RE: Response to TCEQ NOD 3 Addendum – CCR105
Luminant Generation Company LLC – Tatum, Rusk County
Industrial Solid Waste Registration No. 31277
EPA Identification No. TXD000821306
Tracking No. 27220868; RN102583093/CN603256413

Table 1 - NOD Summary and Response
Registration No. CCR105 - Luminant Generation Company LLC
Application Deficiencies - Addendum to NOD 3

RE: Response to TCEQ NOD 3 Addendum – CCR Registration No. CCR105
Martin Lake Steam Electric Station - Rusk and Panola Counties, Texas
(SWR 31277; RN102583093; CN603256413; EPA ID No. TXD000821306)

BY: AJD

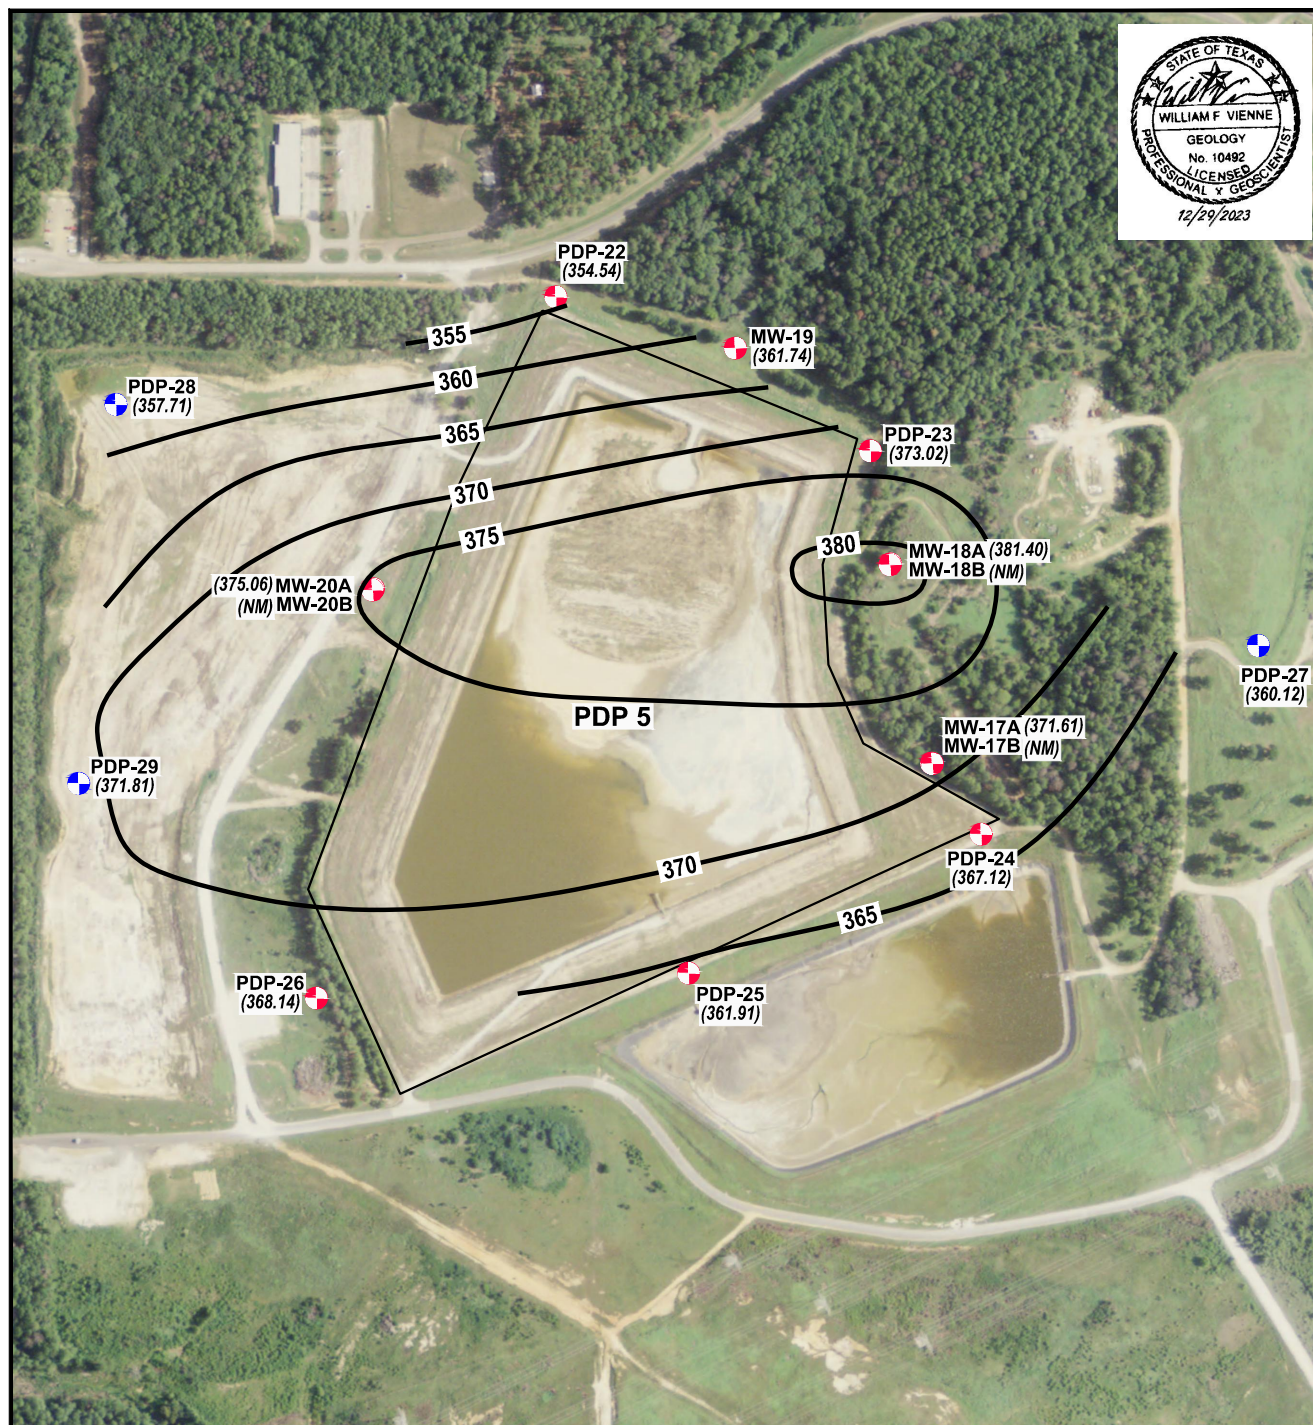
PDP5: Please provide a narrative that addresses the fact there is no true background well because of groundwater mounding and radial groundwater flow centered on well MW-18A.

PDP-5 was constructed in 2010, prior to the CCR Rule being issued by EPA in 2015. PDP-5 has been registered and regulated under the TCEQ IHW Program as industrial non-hazardous solid waste management unit No. 024 (TCEQ Solid Waste Registration No. 31277) since it was constructed. TCEQ reviewed the PDP-5 monitoring well network as part of the registration package that was submitted to and approved by the TCEQ IHW Program. Several monitoring wells have been replaced or added over time, but the current monitoring well locations are similar to those that the TCEQ approved as part of the IHW registration approval.

GEOLOGIC CROSS SECTION A-A'

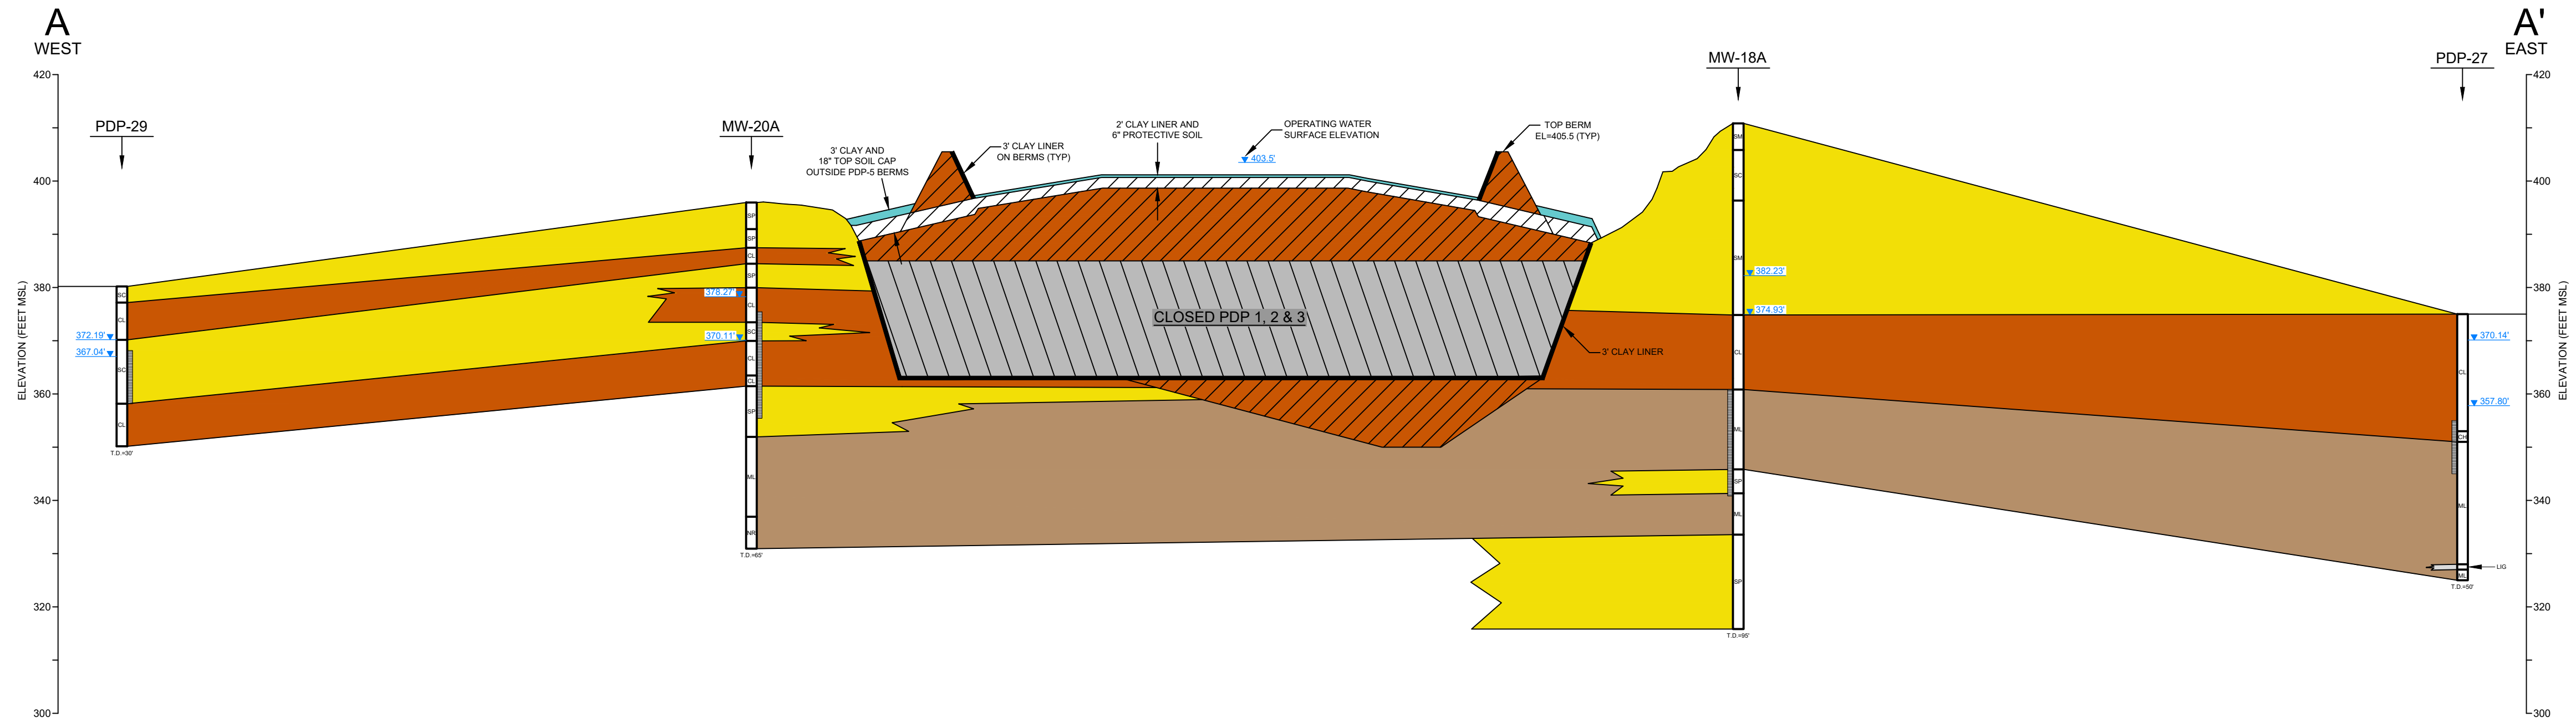
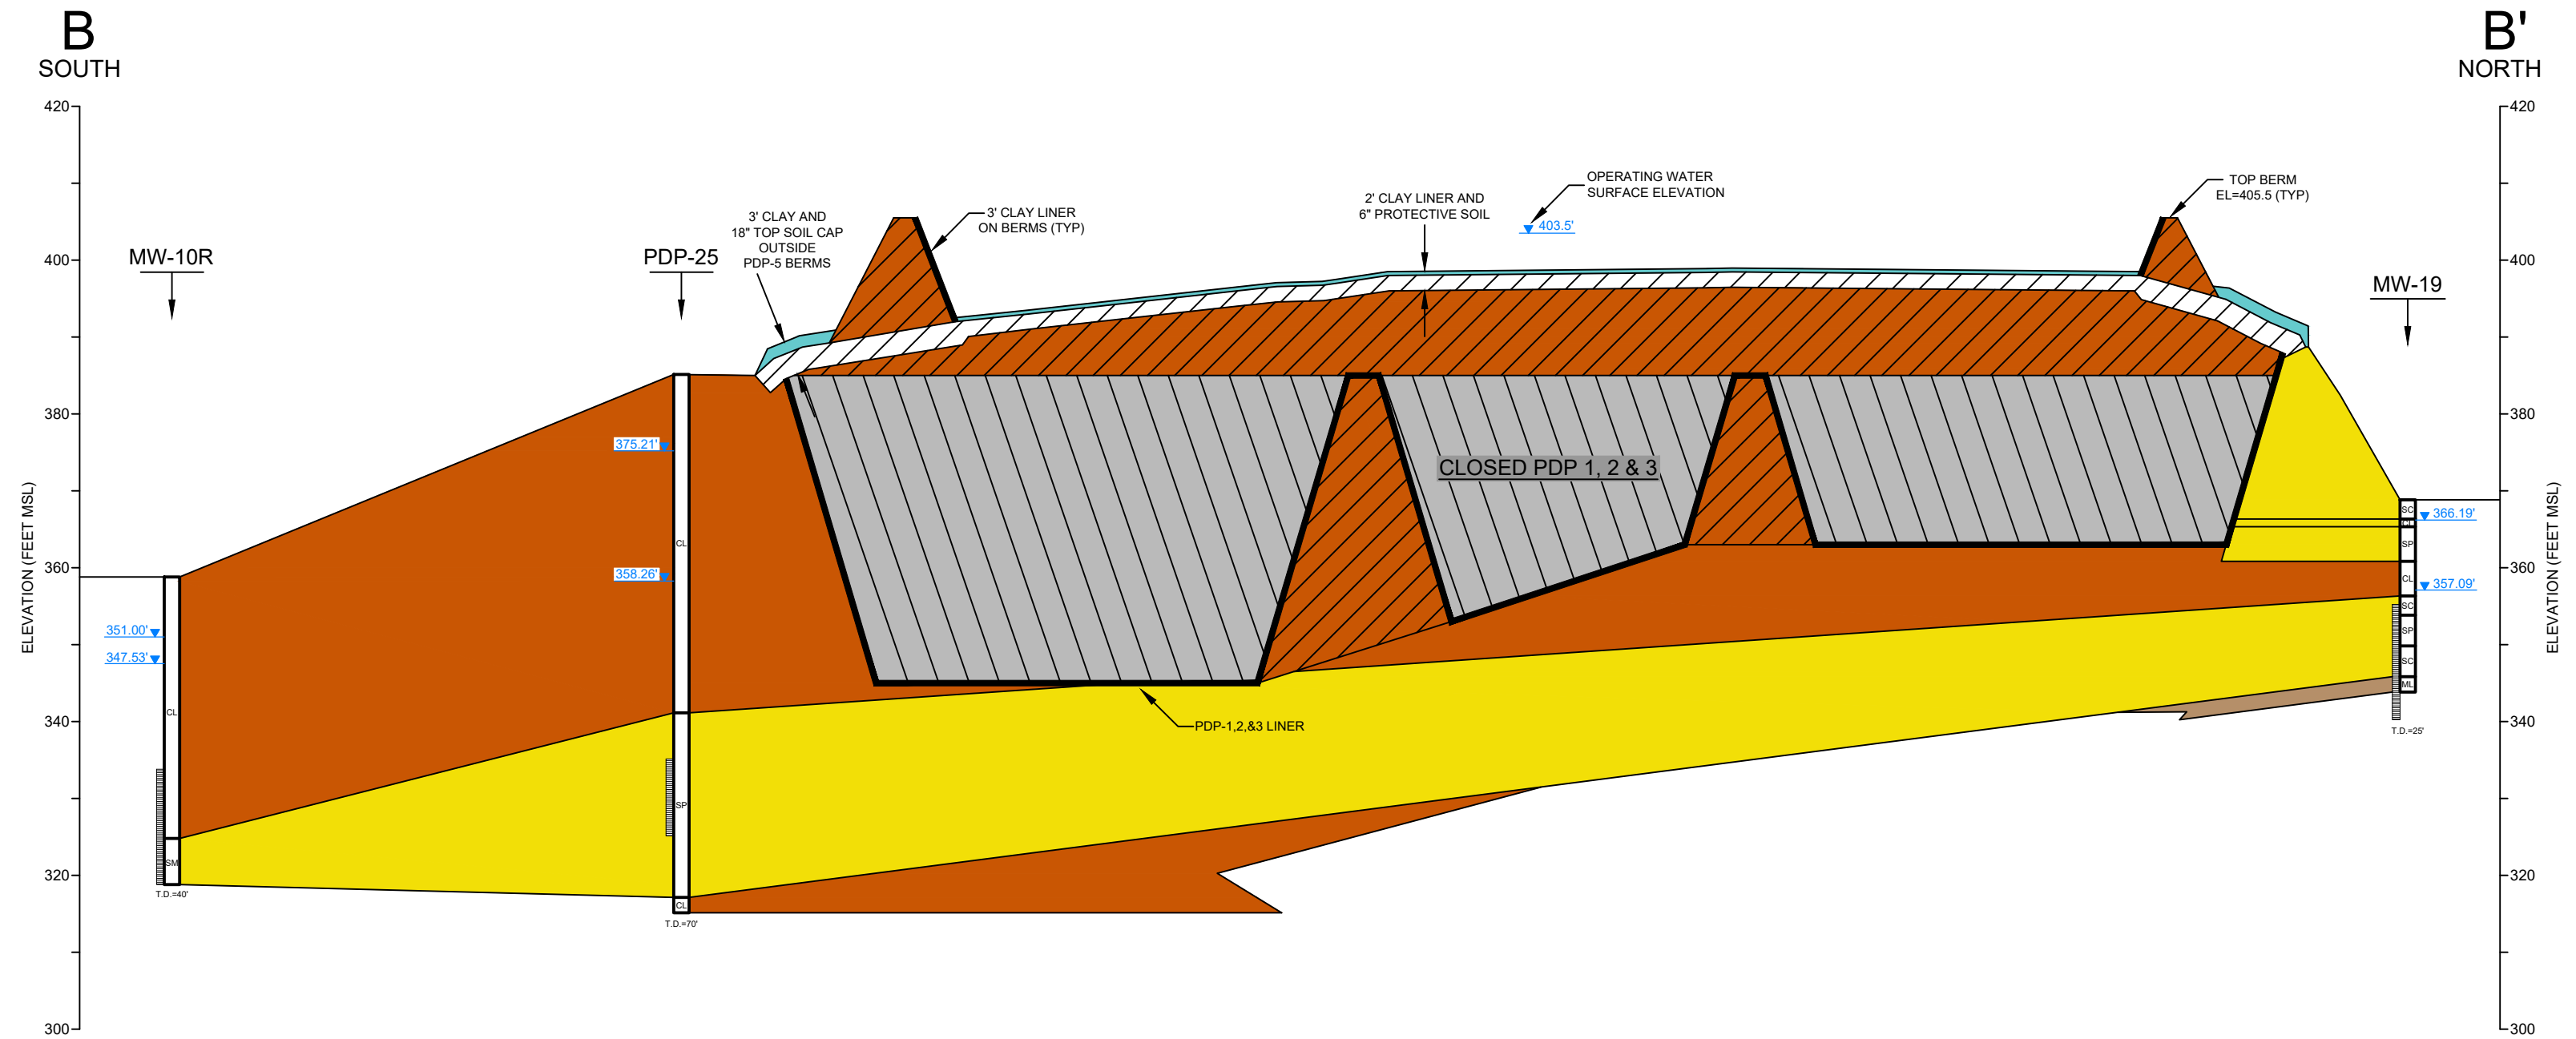
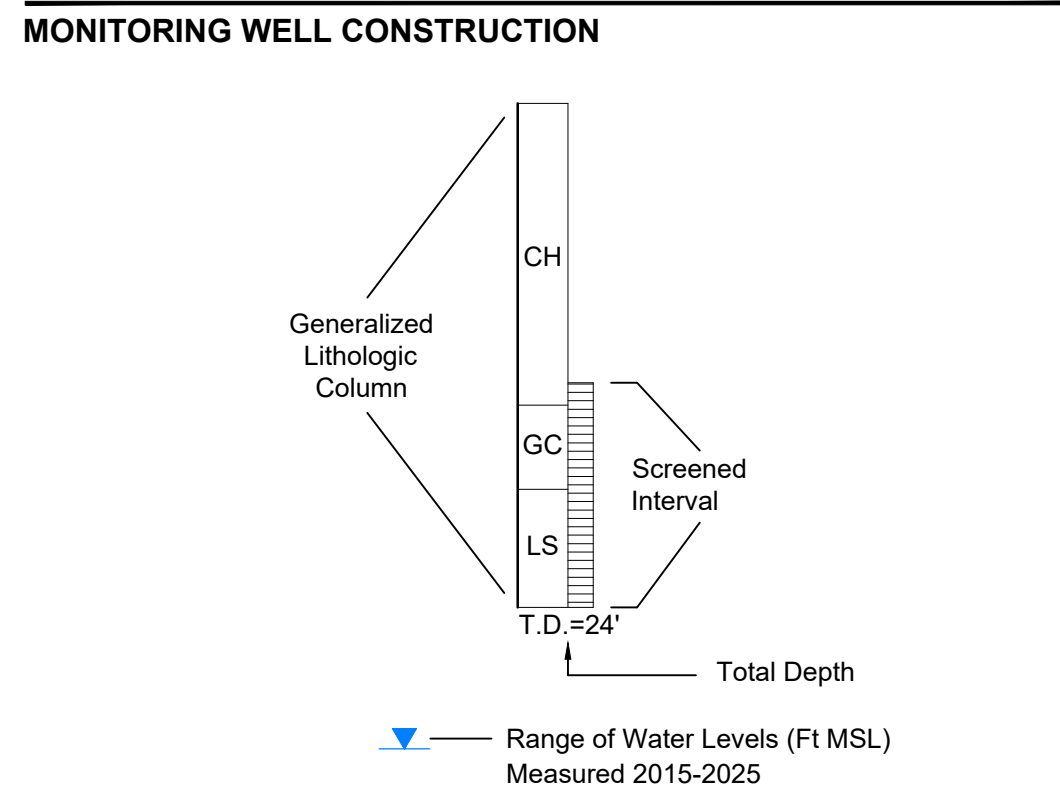
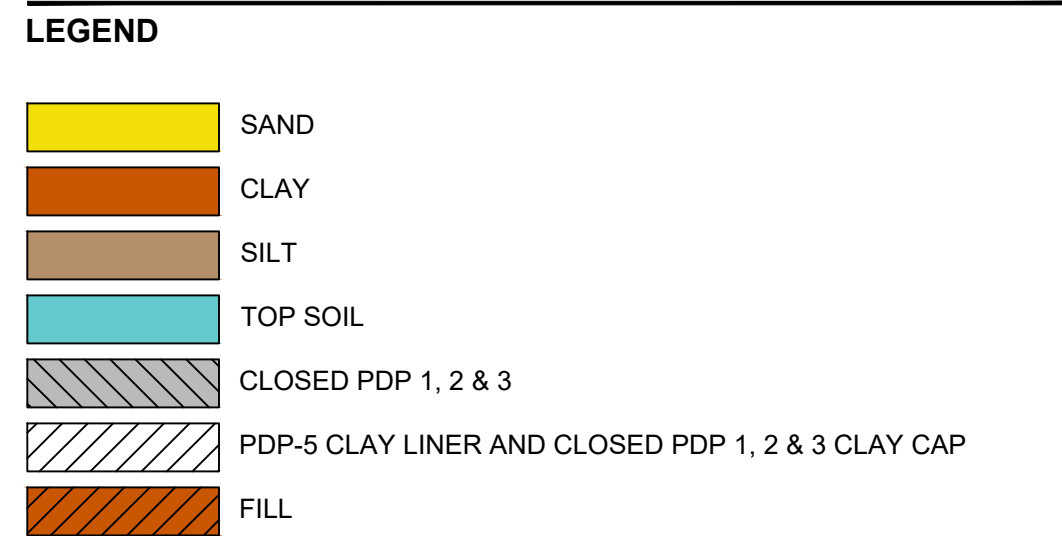
Update the geological cross sections across the PDP-5 Surface Impoundment (and the closed PDPs-1, 2 and 3) (A-A' and B-B') to include other nearby wells to extend the subsurface geology beyond the unit boundary. Also include the historical highest and lowest groundwater levels at each additional well added to the cross section.
